# SITE DEVELOPMENT PLAN DORSEY CENTER APARTMENTS, PARCEL 'T' 1ST ELECTION DISTRICT HOWARD COUNTY, MARYLAND

PLEASE NOTE THAT THIS REVISION SUPERSEDES AND REPLACES THE NOVEMBER 2020 BEI PLAN SHEET.

| LOCATION:<br>TAX MAP 37<br>PARCEL 375 - GRID 24<br>1st ELECTION DISTRICT<br>HOWARD COUNTY, MARYLAND  | TITLE:<br>LAYOUT PLAN AND<br>BIKE ROUTE TO DEERPATH BIKE LANES |

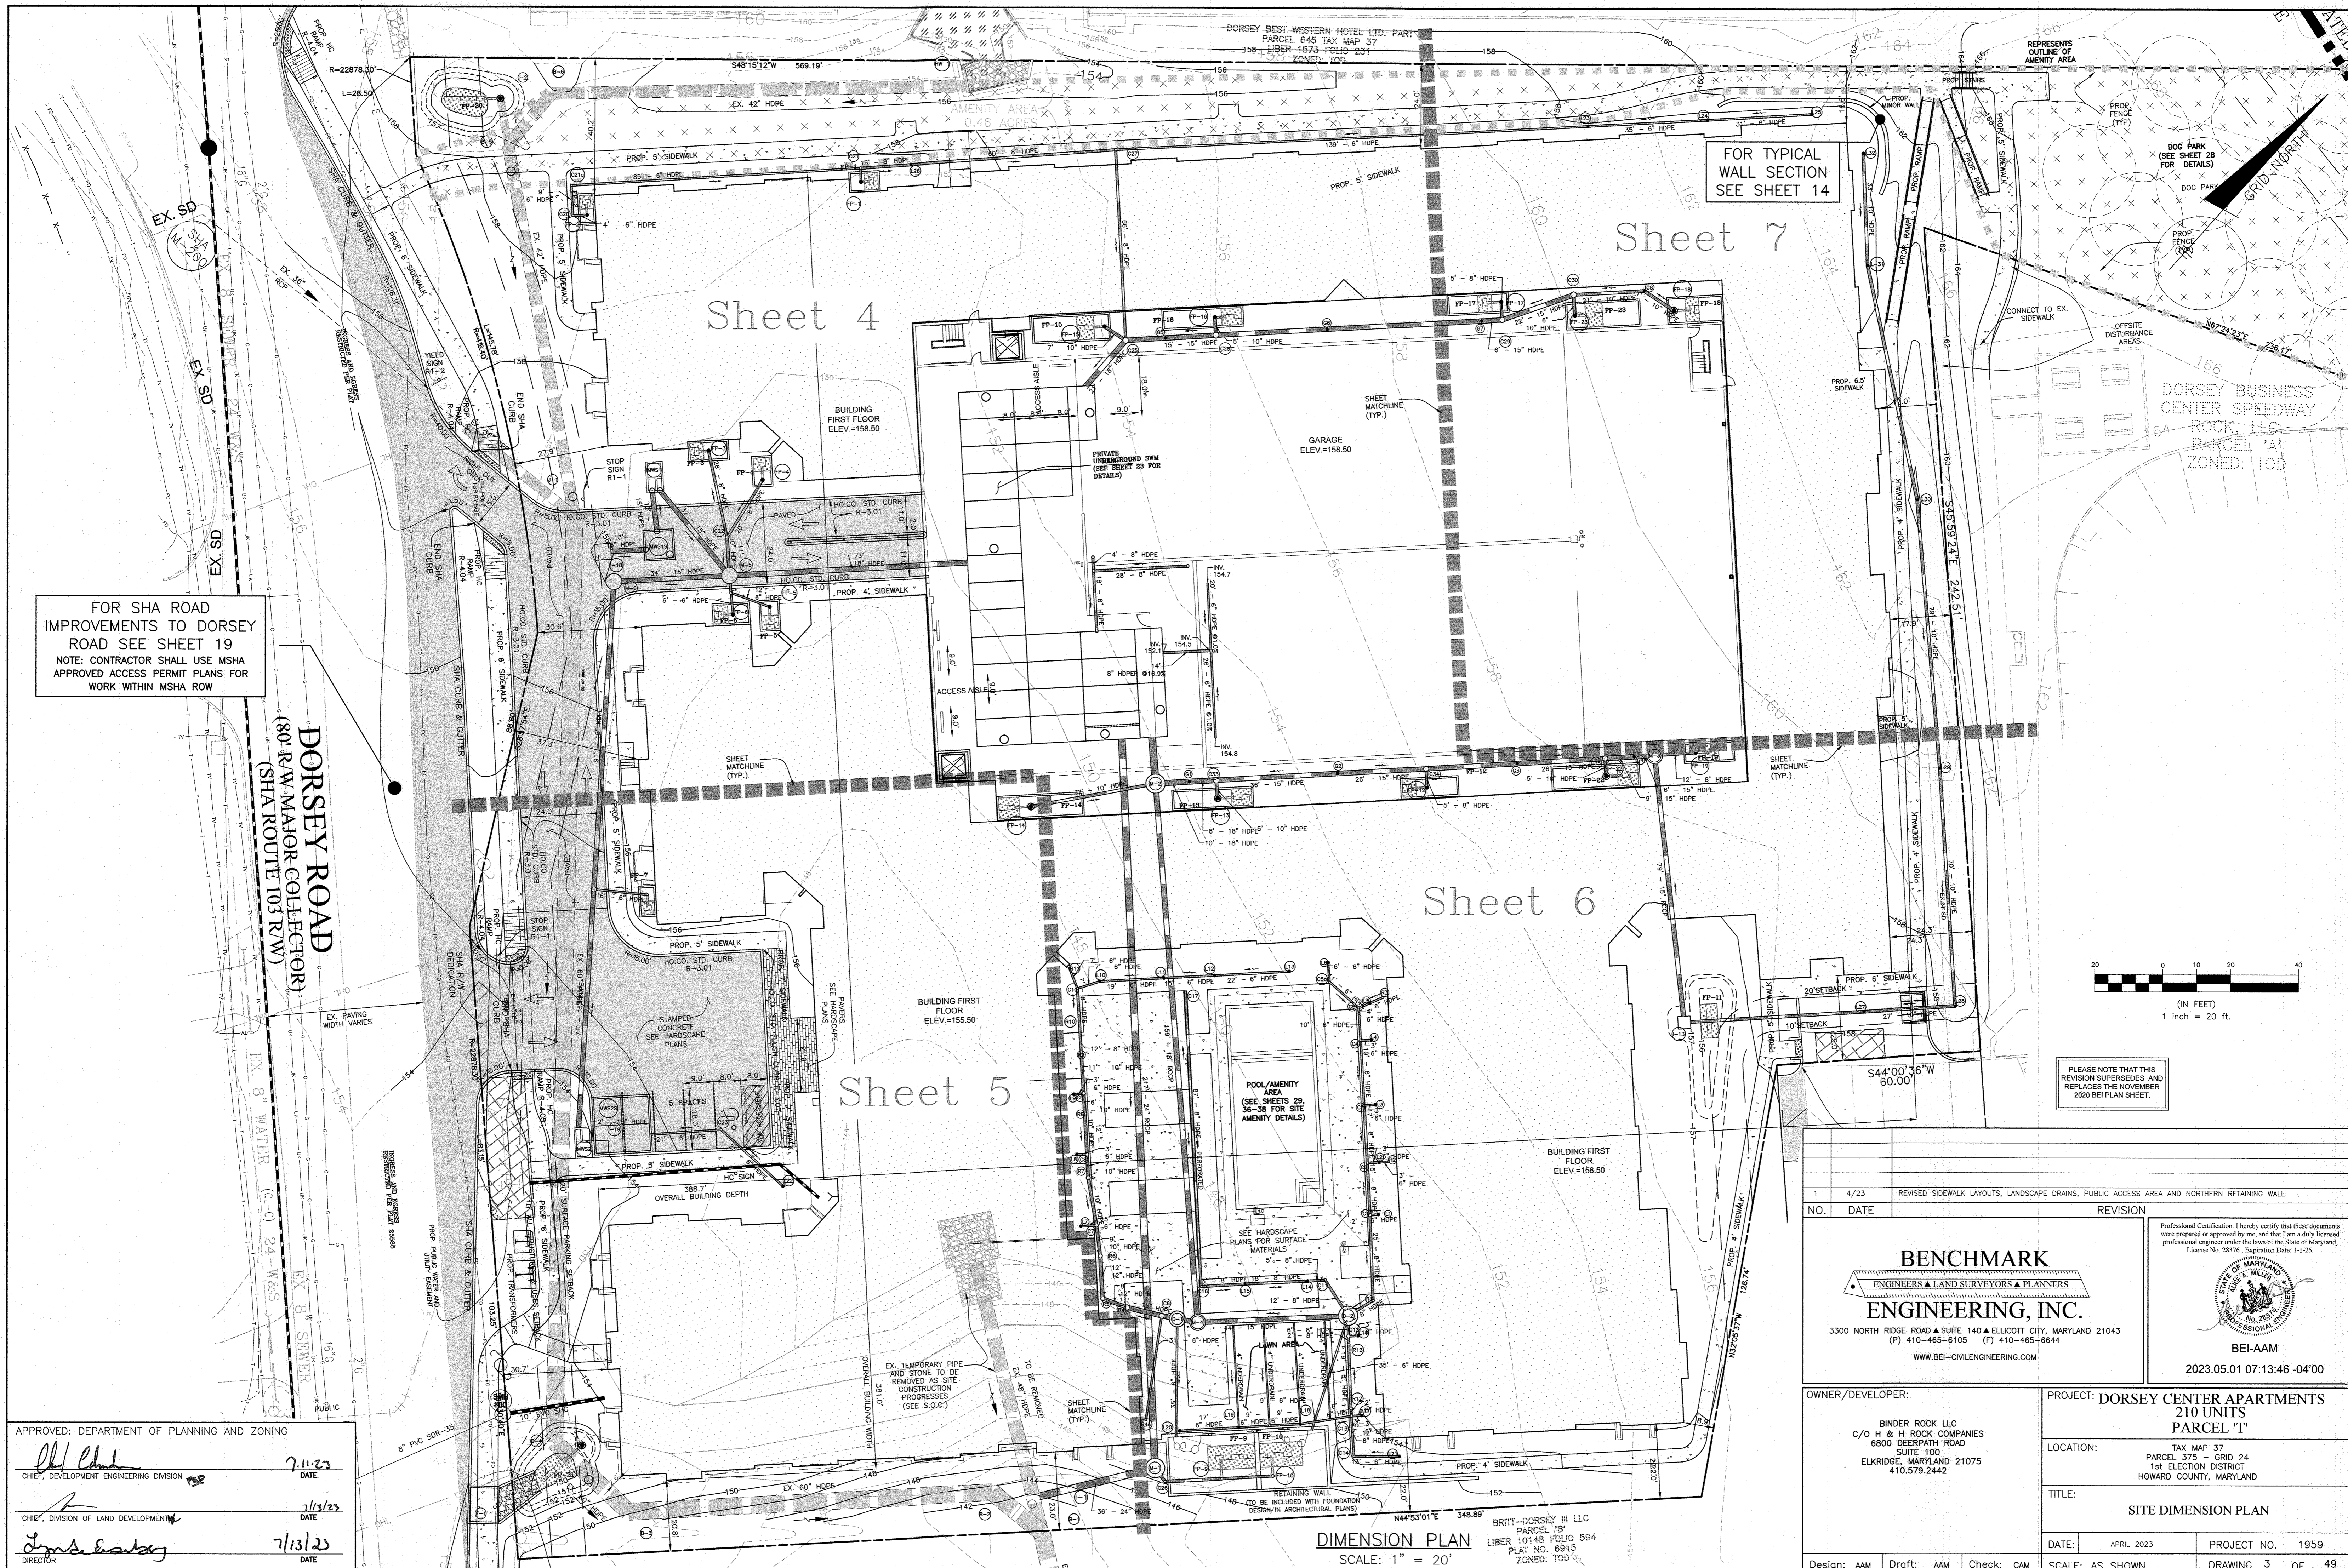
| NO. | DATE | REVISION  |
|-----|------|---|
| 1   | 4/28 | REMOVED BOULDER STAIRS, REVISED NORTH AND REAR SIDEWALKS AND REMOVED NORTHEAST RETAINING WALL. REVISED FRONT SIDEWALKS, AND EDC LOCATIONS. REVISED PUBLIC AMENITY AREA. |

| BINDER ROCK LLC<br>C/O H & H ROCK COMPANIES<br>6800 DEERPATH ROAD<br>SUITE 100<br>ELK RIDGE, MARYLAND 21075<br>410.579.2442  | LOCATION: TAX MAP 37 PARCEL 375 - GRID 24 1st ELECTION DISTRICT HOWARD COUNTY, MARYLAND<br>TITLE: SITE DIMENSION PLAN |

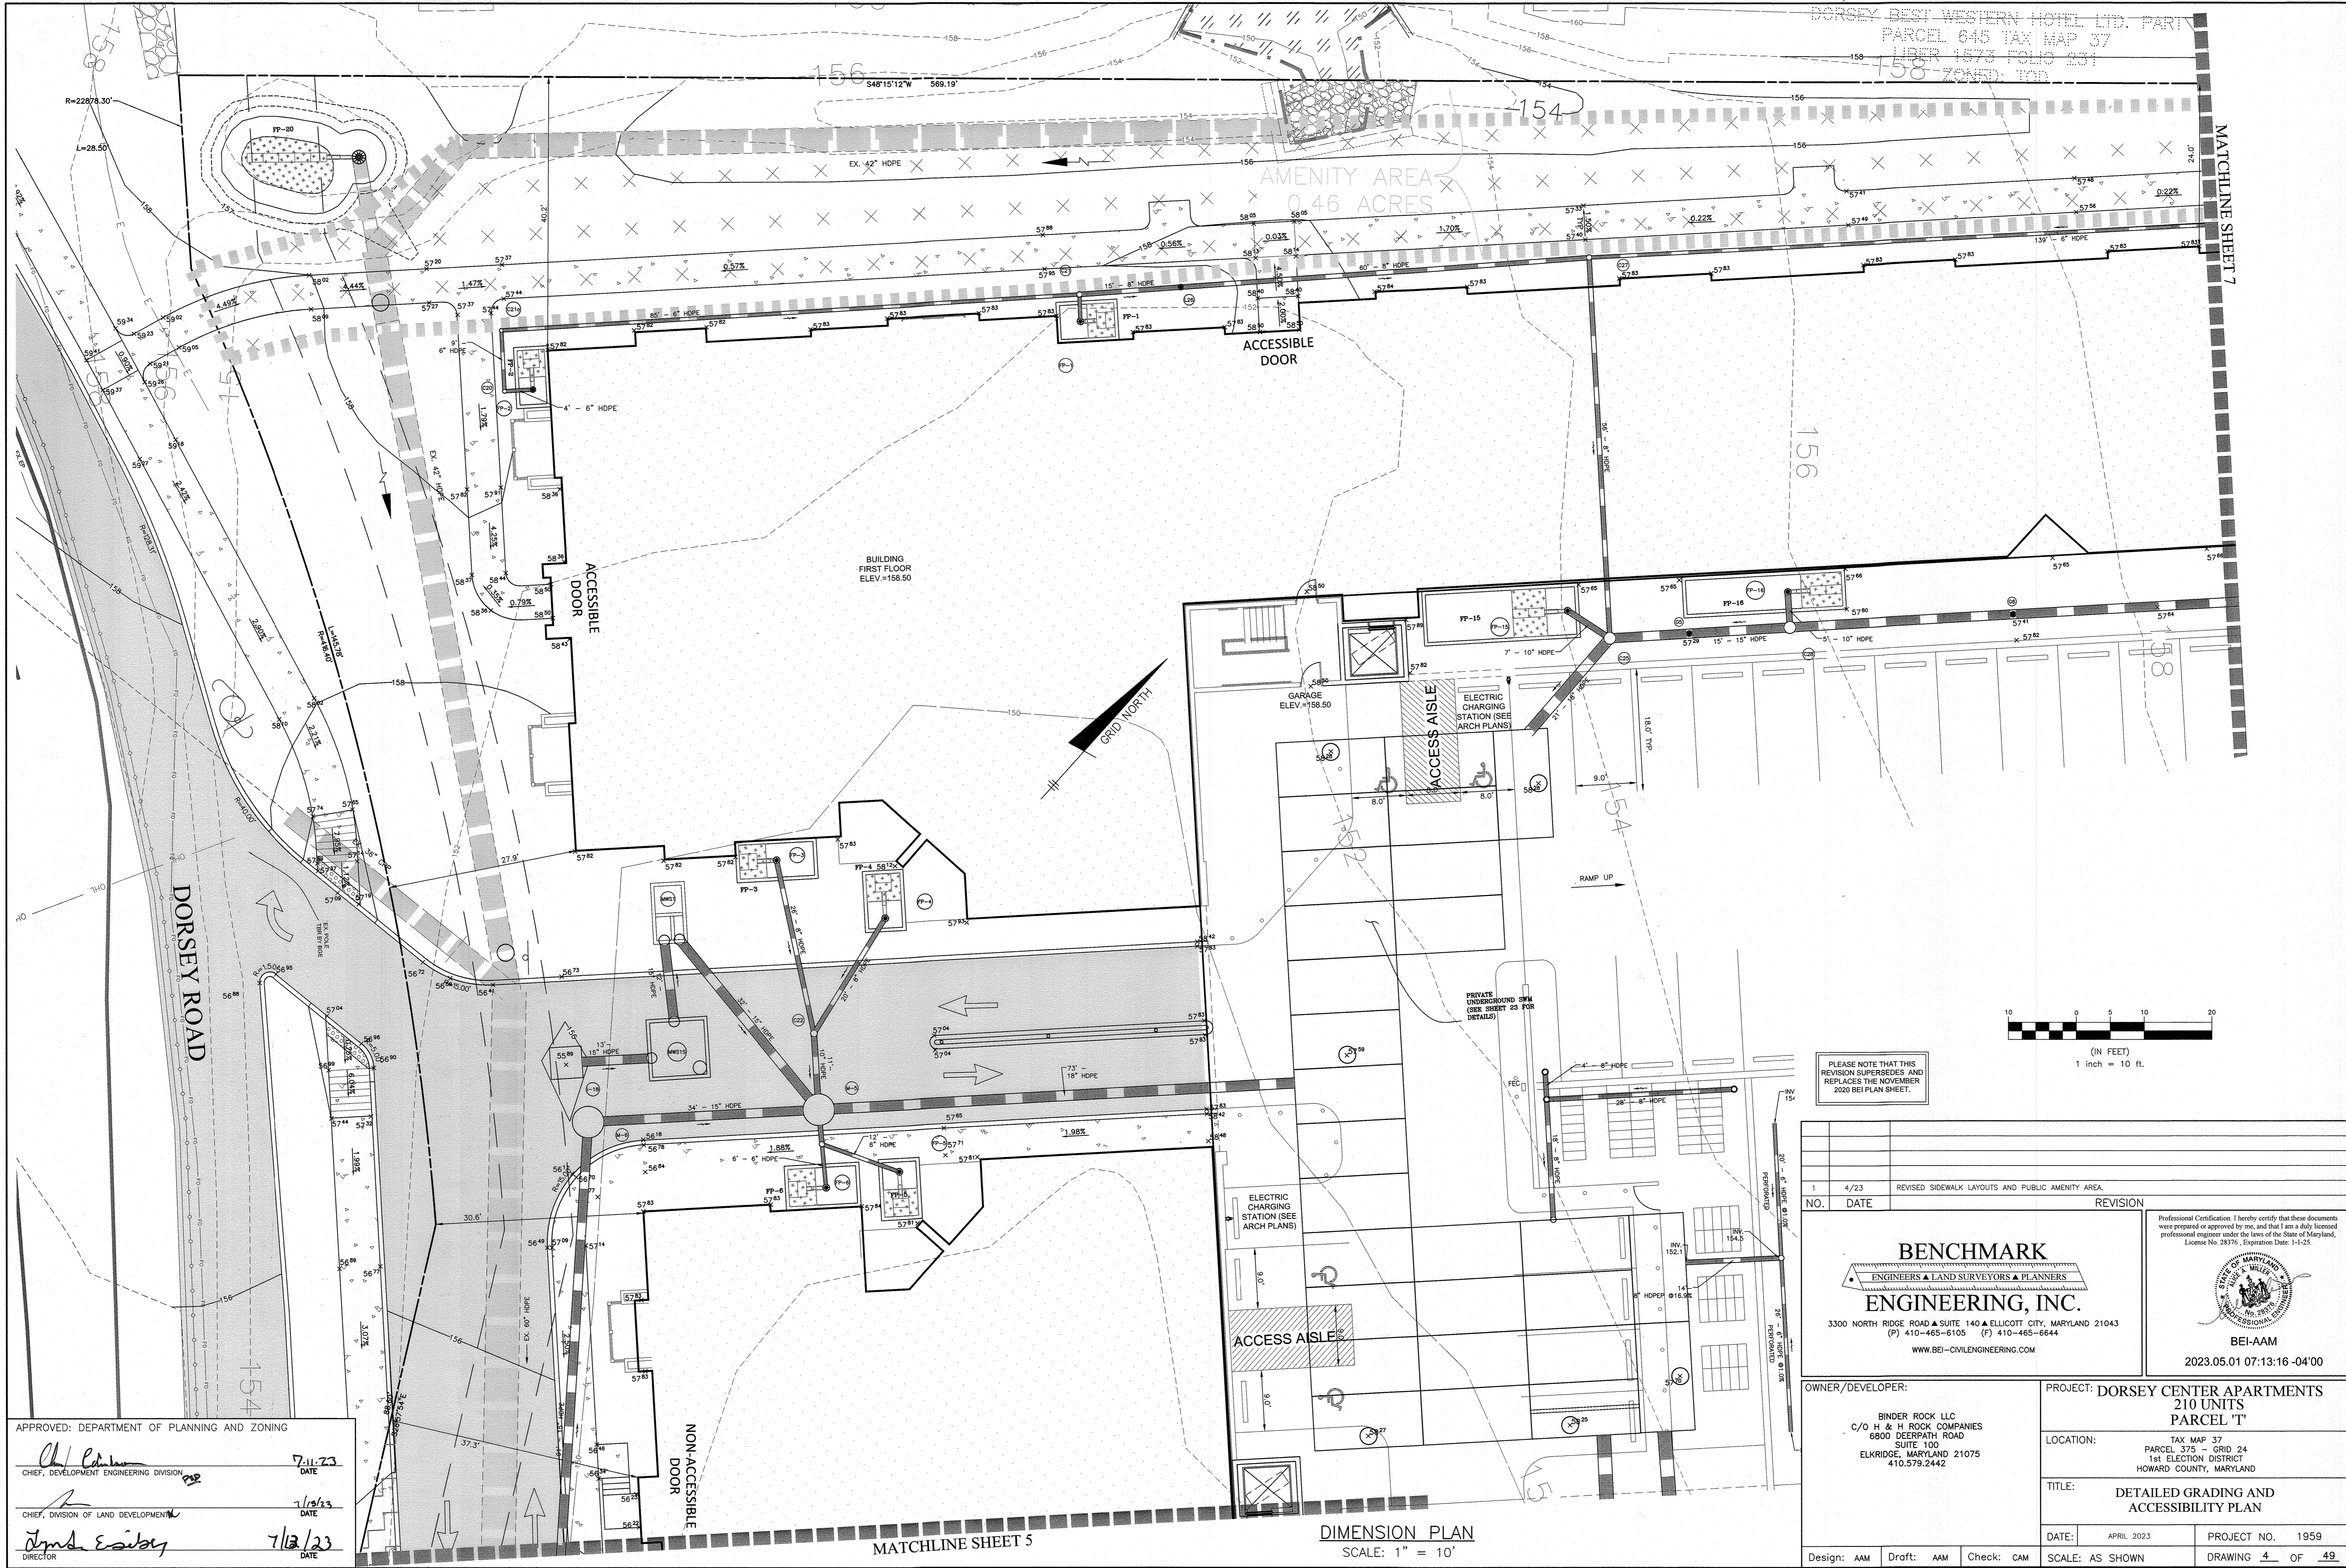
| 1 4/23 REVISED SIDEWALK LAYOUTS, LANDSCAPE DRAINS, PUBLIC ACCESS AREA AND NORTHERN RETAINING WALL.   |   |

| TITLE:  |            |             | DETAILED GRADING AND ACCESSIBILITY PLAN  |            |

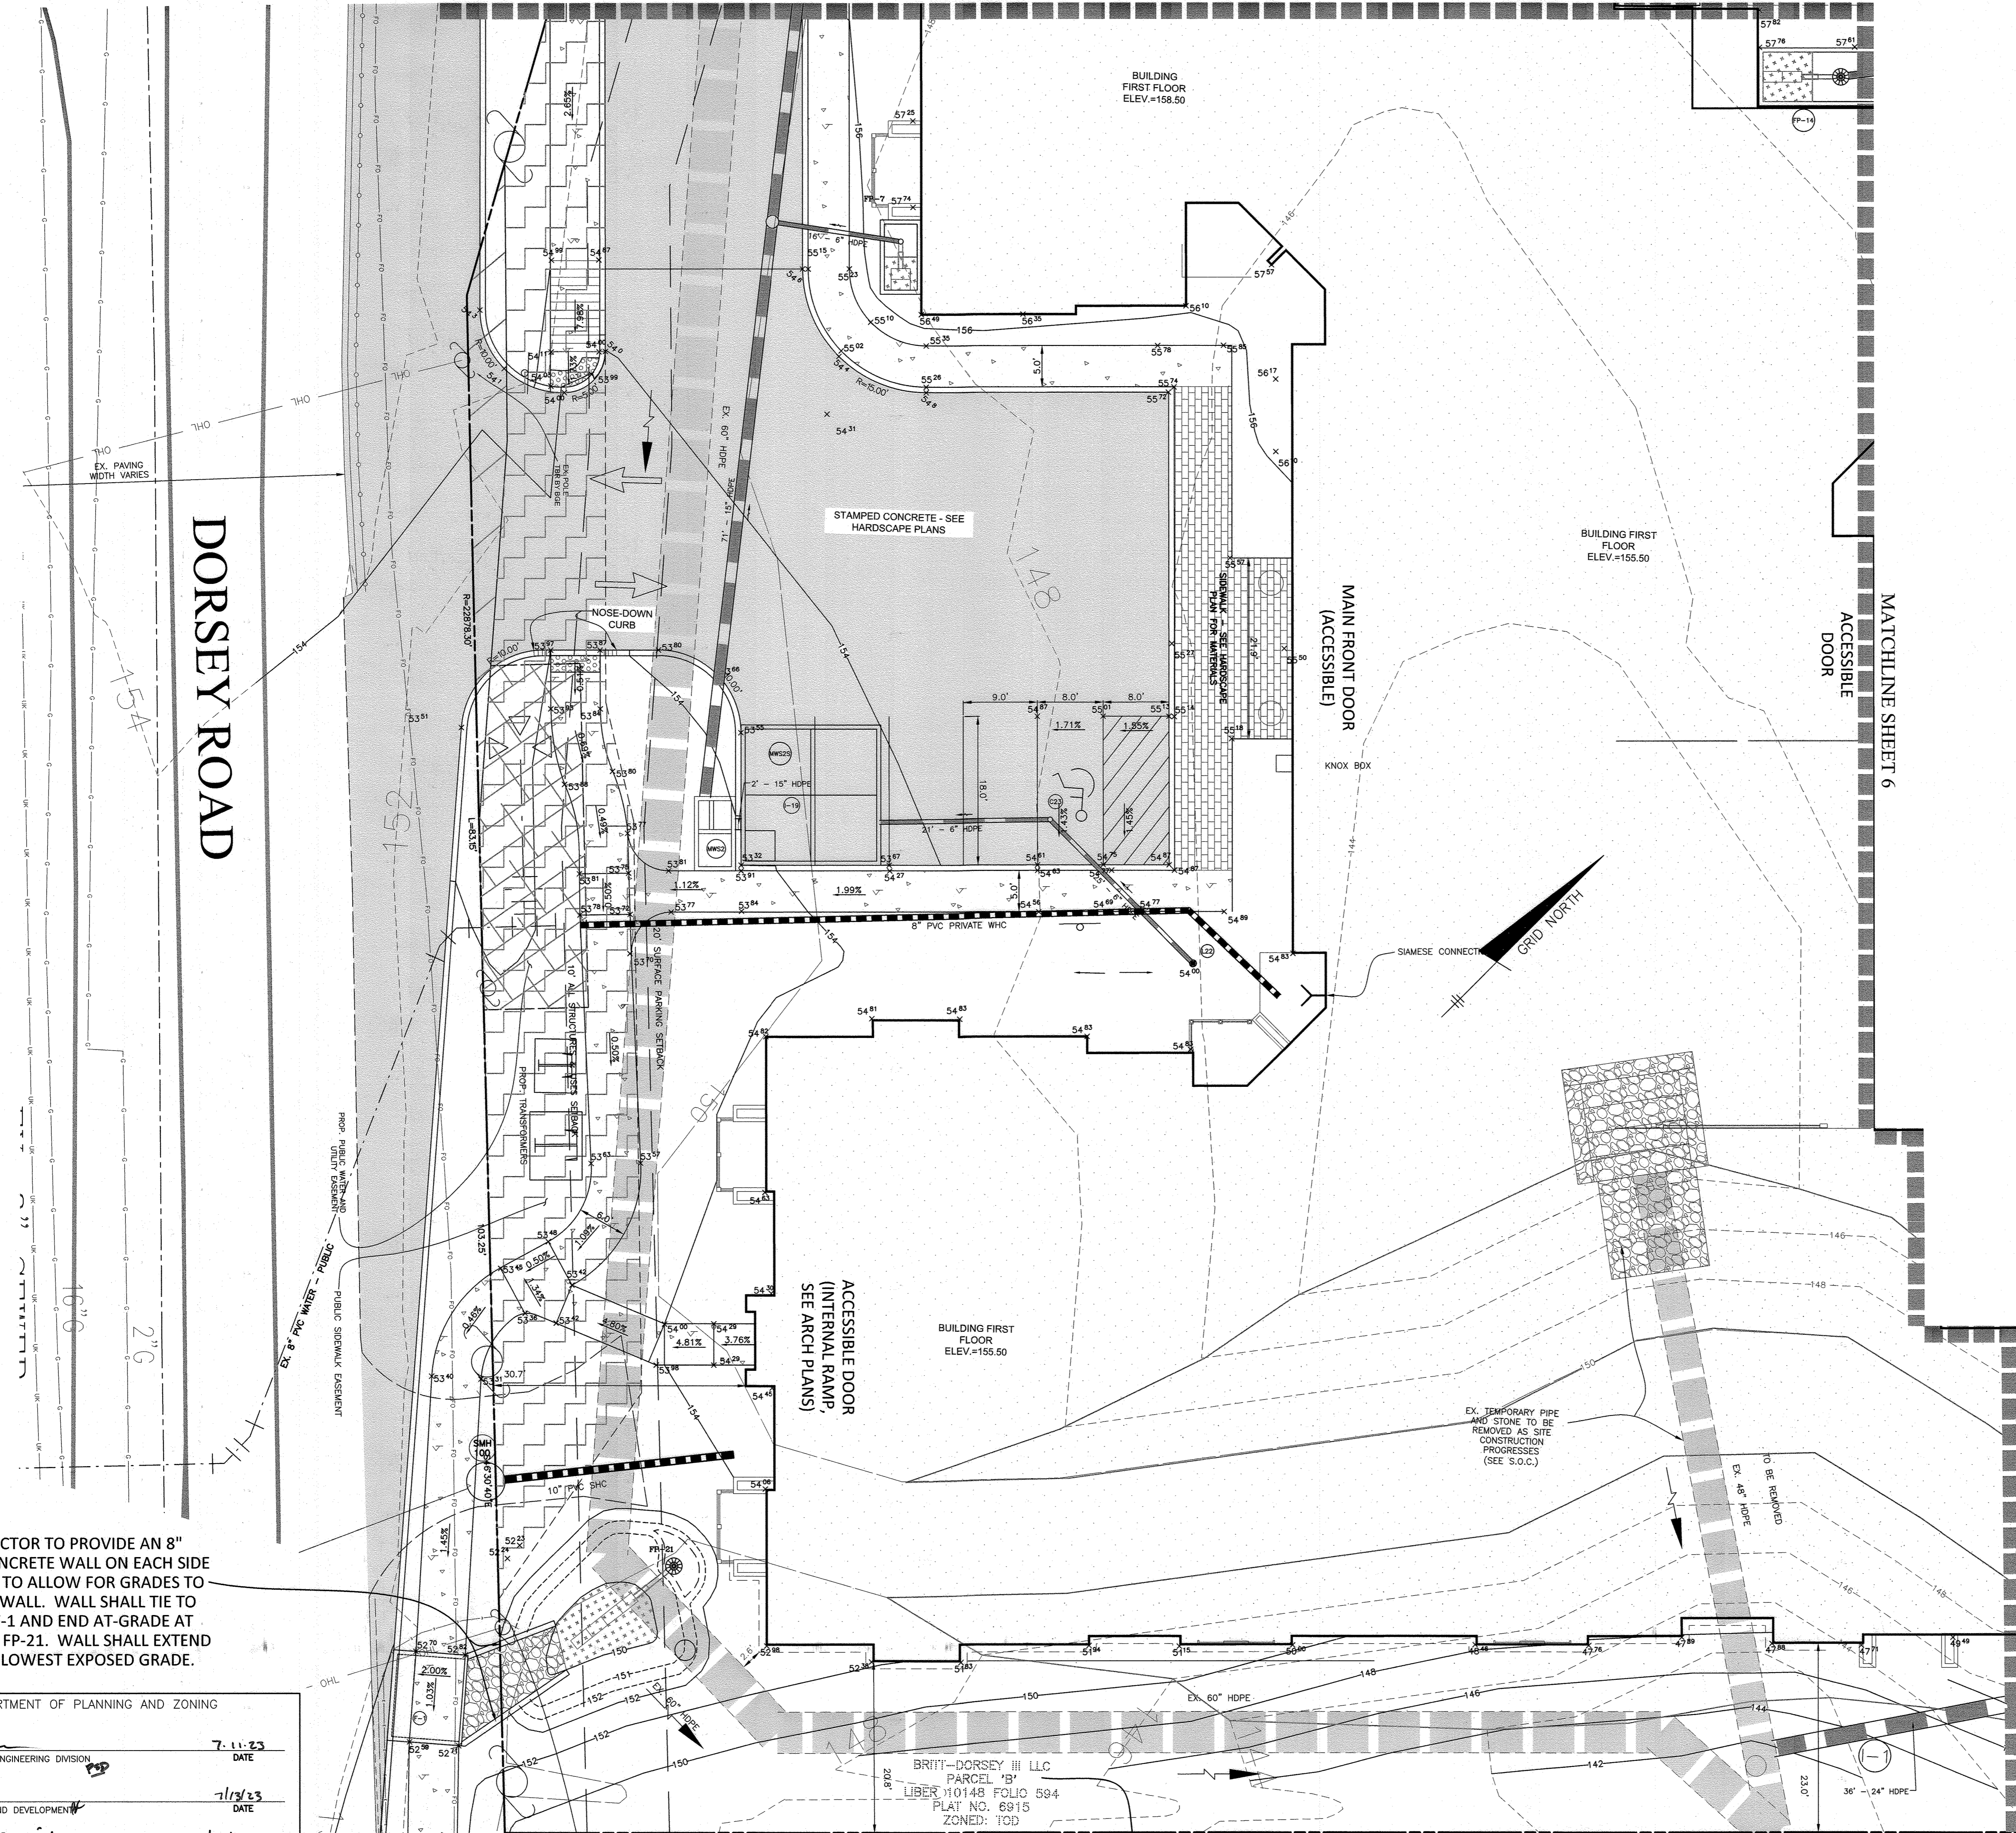
| 1   |            | 4/23        | REVISED SIDEWALK LAYOUTS AND PUBLIC AMENITY AREA.                                  | REVISION   |
